From: "Ben Collings - BNC Planning" <bnc@bncplanning.com.au>
Sent: Thu, 27 Mar 2025 08:57:48 +1000
To: "Taryn Pace" <taryn.pace@townsville.qld.gov.au>
Cc: "Development Assessment" <developmentassessment@townsville.qld.gov.au>
Subject: MCU24/0108 - 1-105 Racecourse Road, Cluden
Attachments: Combined RFI AN Response.zip

RE: APPLICANT COMBINED RESPONSE TO ASSESSMENT MANAGER INFORMATION REQUEST & REFERRAL AGENCY INFORMATION REQUEST AND ADVICE NOTICE

PRELIMINARY APPROVAL - VARIATION REQUEST TO OVERRIDE THE PLANNING SCHEME TO FACILITATE DEVELOPMENT IN ACCORDANCE WITH THE TOWNSVILLE WATERPARK, HOTEL, AND BEACHCLUB PLAN OF DEVELOPMENT COMBINED WITH DEVELOPMENT PERMIT - RECONFIGURING A LOT (BOUNDARY REALIGNMENT)

1-105 RACECOURSE ROAD CLUDEN QLD 4811 - LOT 2 RP 748152 & LOT 1 SP 101275

Fig 1 – 1% AEP Railway Corridor Time of Submergence

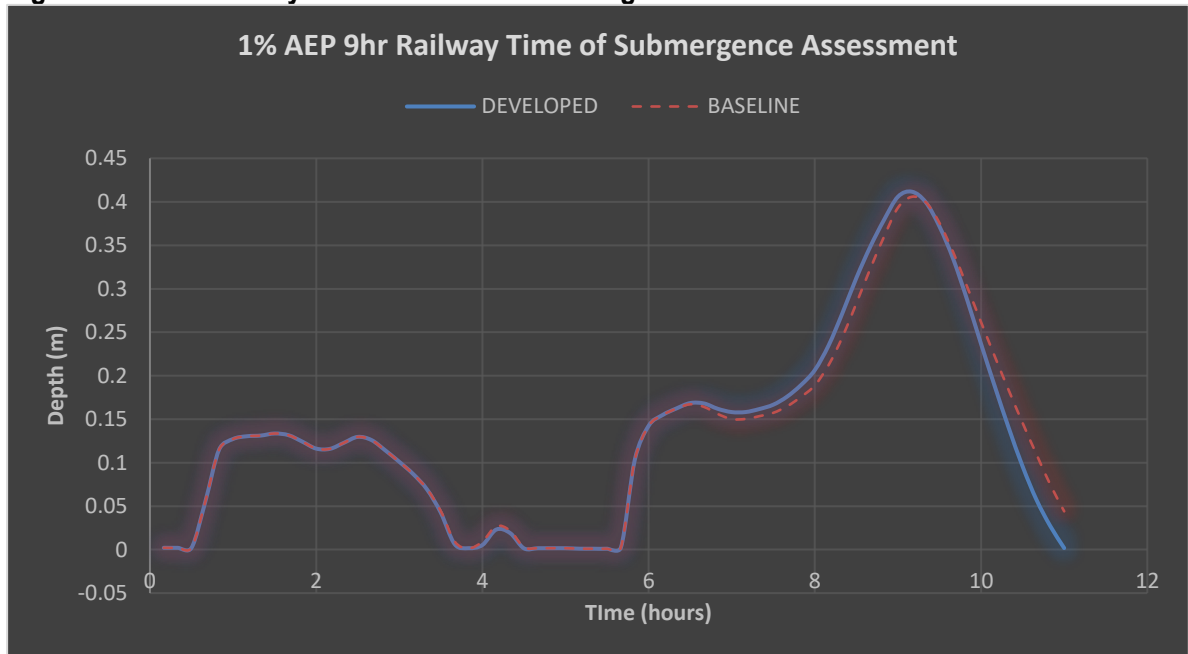
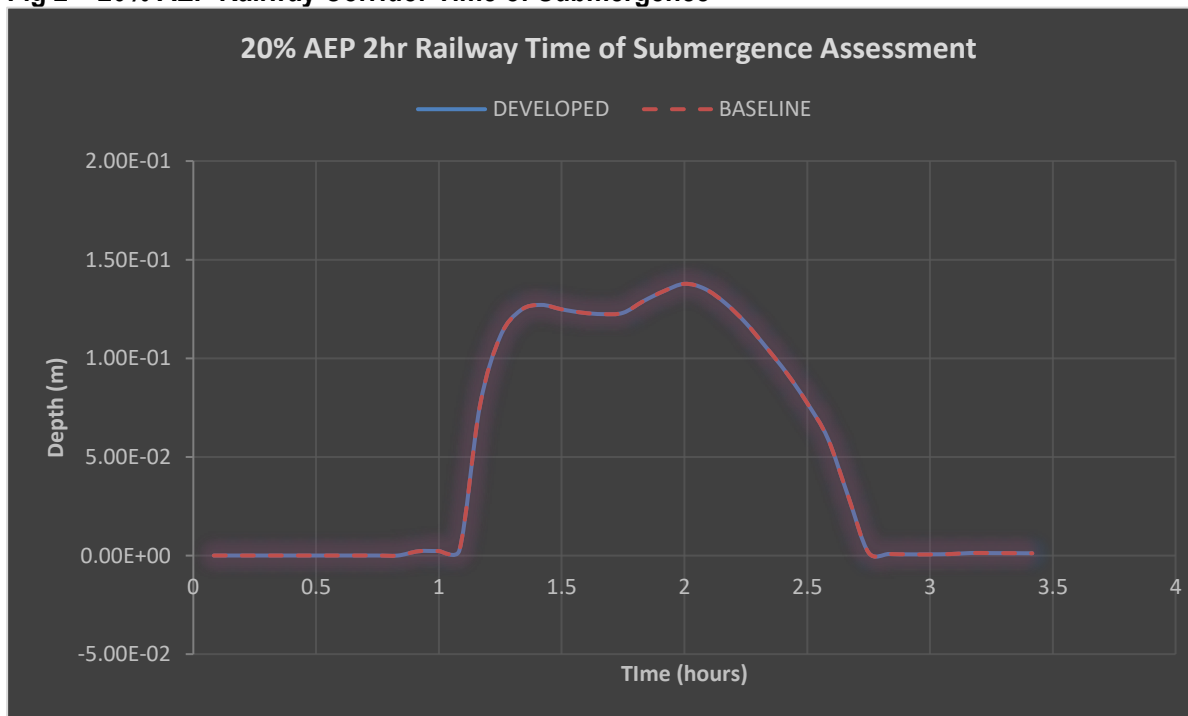
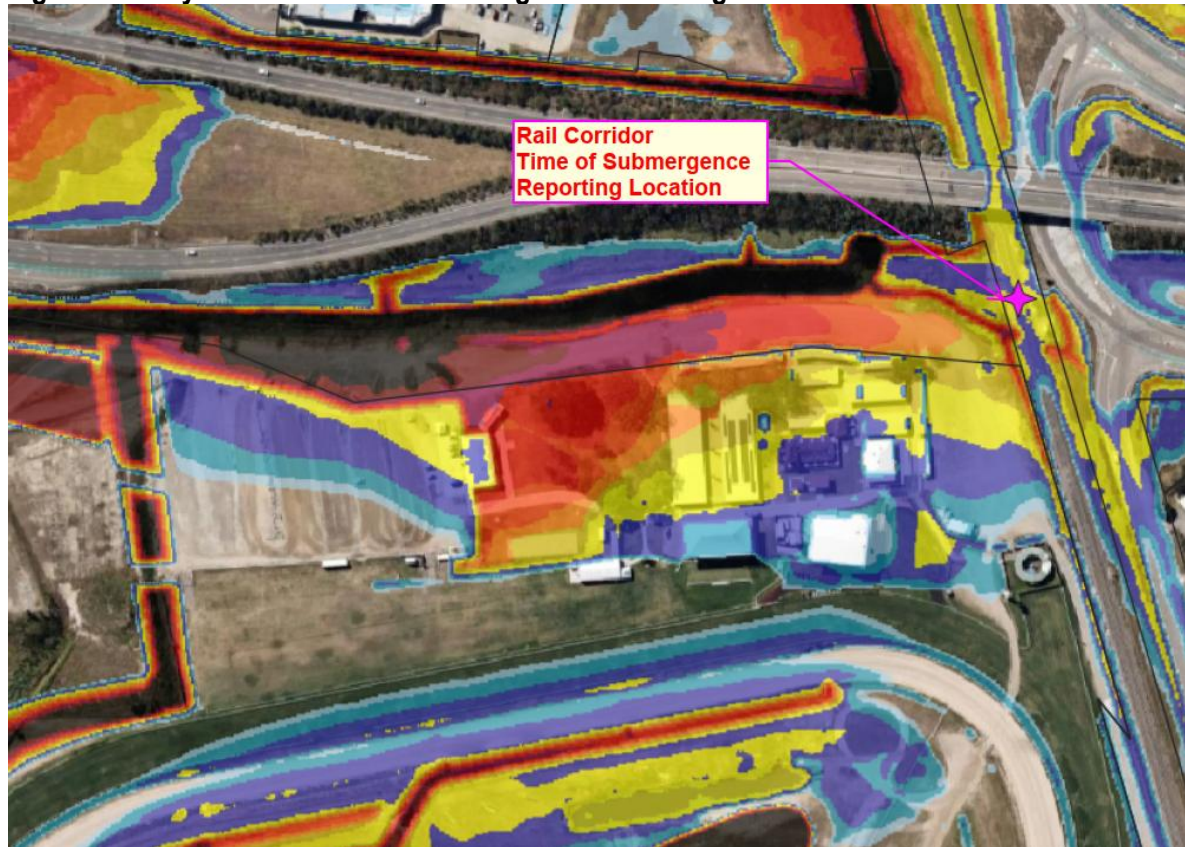
- *There are conflicts apparent between the development layouts and FIA figures, in particular the building footprints are shown overlapping with detention basins. The plans and/or flood study is requested to be updated to clarify this;*
- *The FIA has considered only the 1% and 20% AEP design storm events. The FIA is requested to be amended to consider the full suite of standard design storm AEPs; and*
- *The report makes reference to a critical duration discrepancy in the Ross River 2021 model, however it is unclear what this is referring to. The relevant critical duration data and mapping was supplied with the model files.*

Additionally, the primary sensitive receptors of the model are the surrounding, adjacent state controlled infrastructure (to the south-west, north and east) as well as the existing turf club infrastructure. NCE have demonstrated non-worsening and in addition, DTMR (via SARA), have confirmed they do not require all events to be assessed.

Figure 1 Access to existing Townsville Turf Club

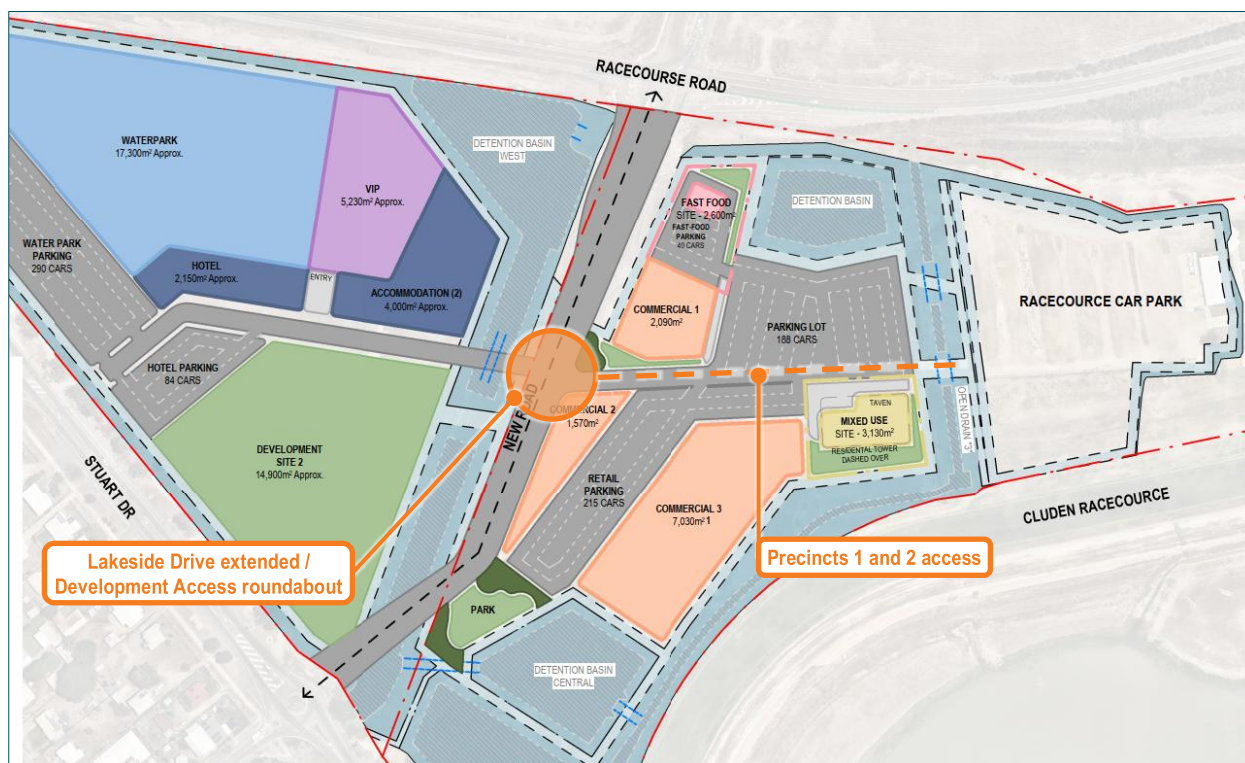
PROPOSED ALLOTMENT LAYOUT PLAN	
6.	<p>Issue:</p> <p><i>In accordance with the abovementioned concerns with the proposed development and accompanying reports, amendments to the 'Plan of Development – Precinct Plan' that informs the 'Townsville Waterpark, Hotel and Beachclub Plan of Development' are required to demonstrate compliance with State Code 1, 2 and 6 of the State Development Assessment Provisions.</i></p>

Access to the existing Townsville Turf Club will be provided via the new Precincts 1 and 2 access road that will connect to the Proposed Lakeside Drive extended / Development Access roundabout as shown in **Figure 1**.
